2013-169

116 Walton Street

Site Alteration

Response for Level 1 site plan submission – project Application ID: 2013-169

ARV 13 HO

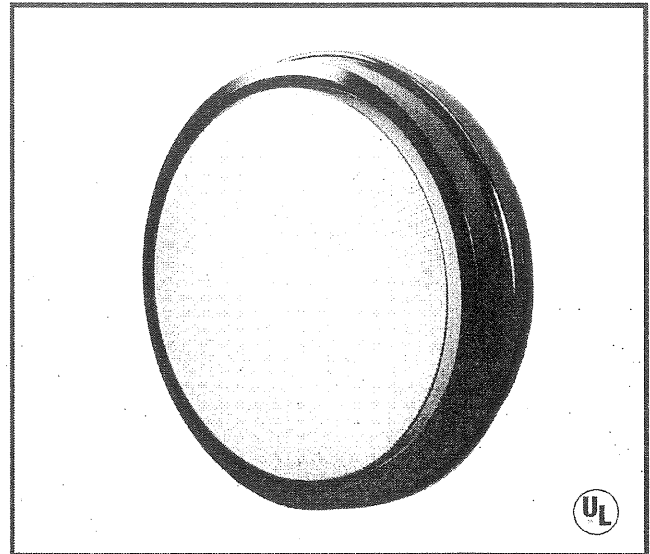
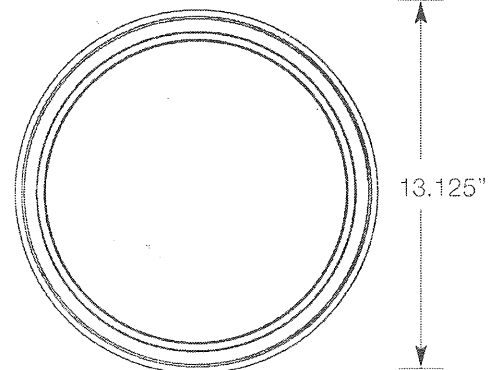
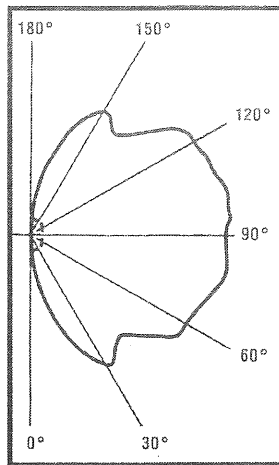
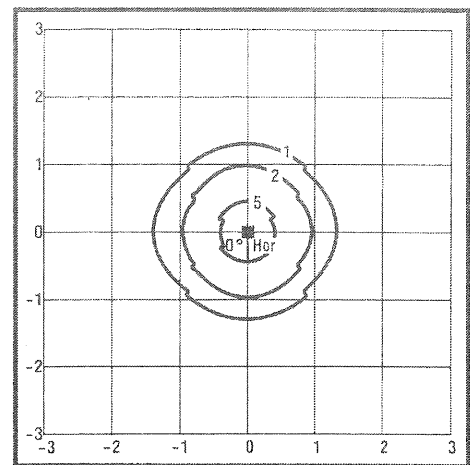
1. Please confirm the existing driveway width will stay the same width. **The driveway curb cut will remain the same width.**
2. Will there be any new exterior lighting being proposed ? If so please show location and photometrics on the site plan. **Please refer to attached plan and product info.**
